April 30, 1982

Subject: Virgil C. Summer Nuclear Station
Docket No. 50/395
NUREG 0737, Item II.F.2
Incore Thermocouple Qualification

Virgil C. Summer Nuclear Station
Existing Incore Thermocouple Installation
Attachment to 4/30/82 letter

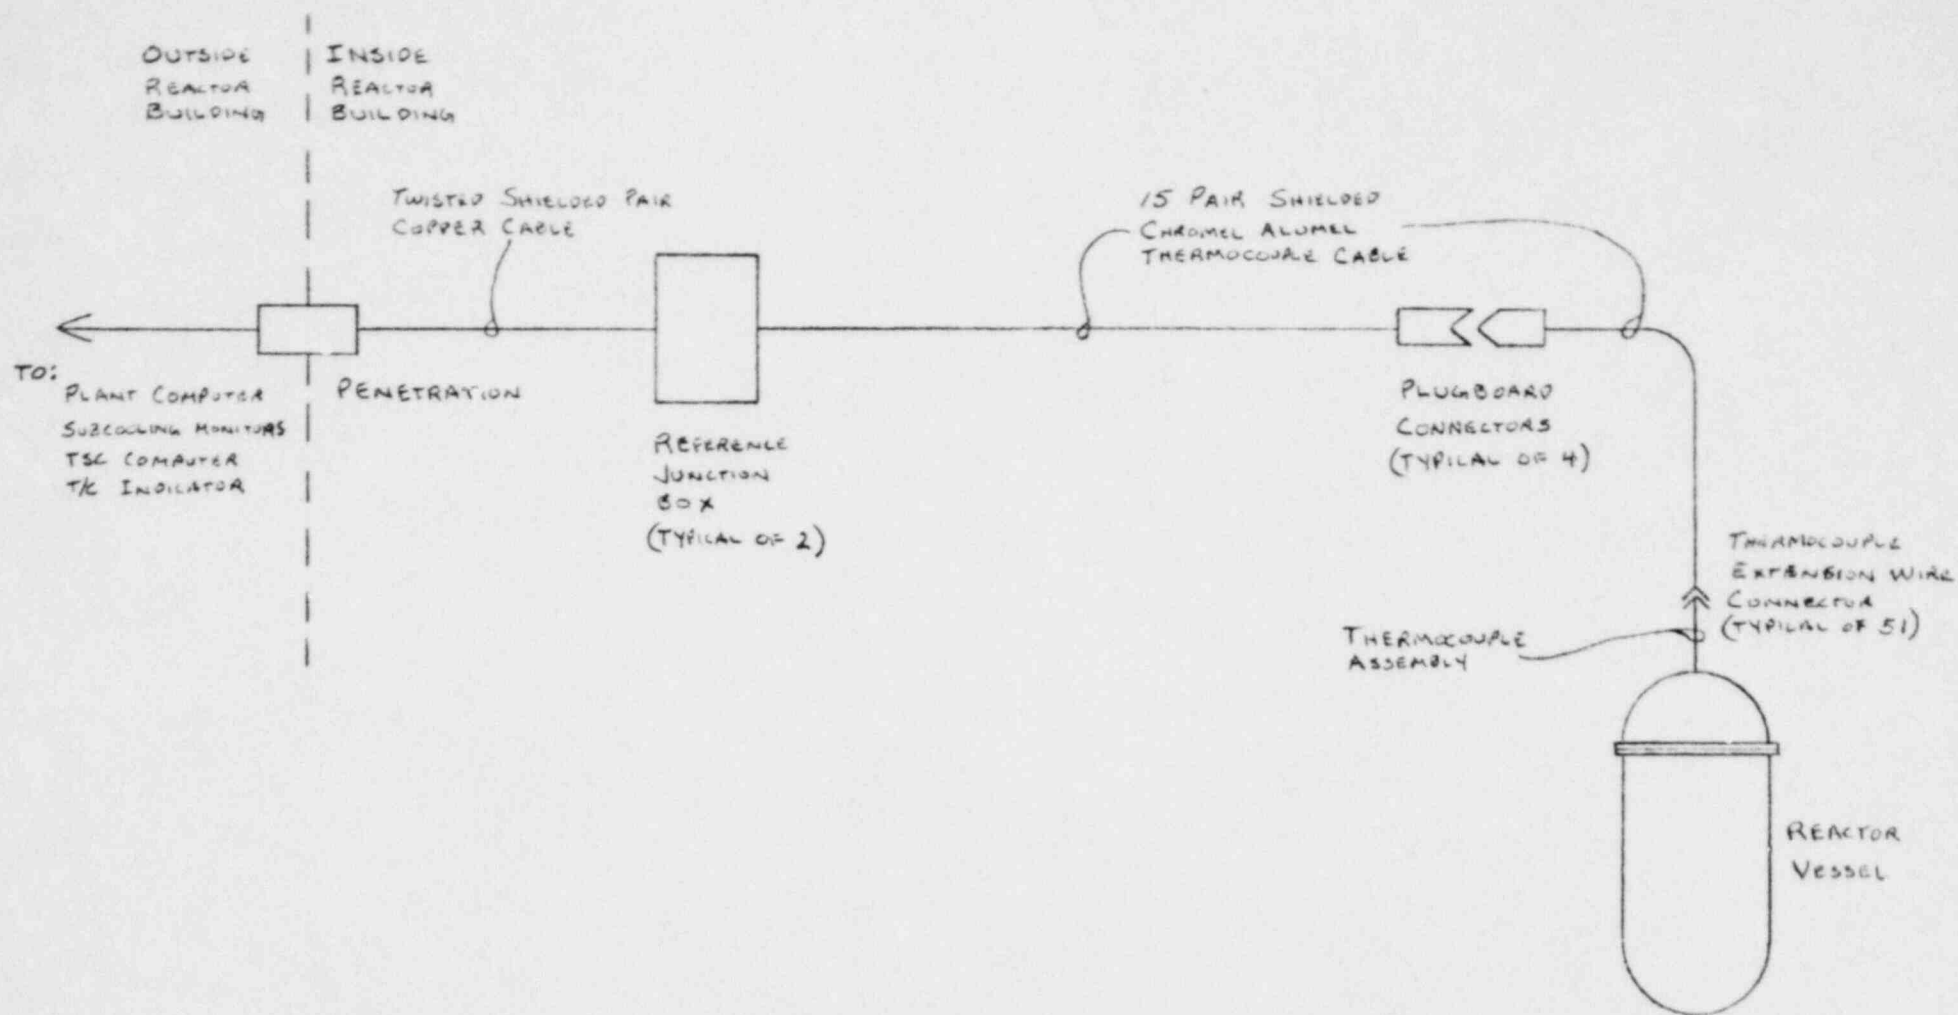
In a recent telephone conference with the NRC Staff, South Carolina Electric and Gas Company (SCE&G) was requested to supply additional information about the existing incore thermocouple installation at the Virgil C. Summer Nuclear Station to supplement the information provided in our letter dated March 16, 1982. Specifically, the Staff requested information that would indicate the expected reliability or usefullness of the existing incore thermocouple installation during and following an event which produces a harsh environment inside the reactor building.

The attached figure provides a schematic of our existing incore thermocouple installation inside the Reactor Building. The 51 stainless steel sheathed chromel alumel incore thermocouple assemblies exit the reactor vessel head and terminate to thermocouple extension wire using Thermo Electric connectors. The thermocouple extension wire used between the thermocouples and the reference junction boxes consists of four(4) 15 pair cables. These cables are routed from the reactor vessel head through four connectors located on a plugboard which facilitates removal of the reactor vessel head and control rod drive mechanisms. From the plugboard the cables are routed to the two reference junction boxes which are located outside the primary and secondary shield walls in a location accessible during operation. Individual twisted shielded pair copper cables are routed from the reference junction boxes to electrical penetrations where the signals exit the Reactor Building.
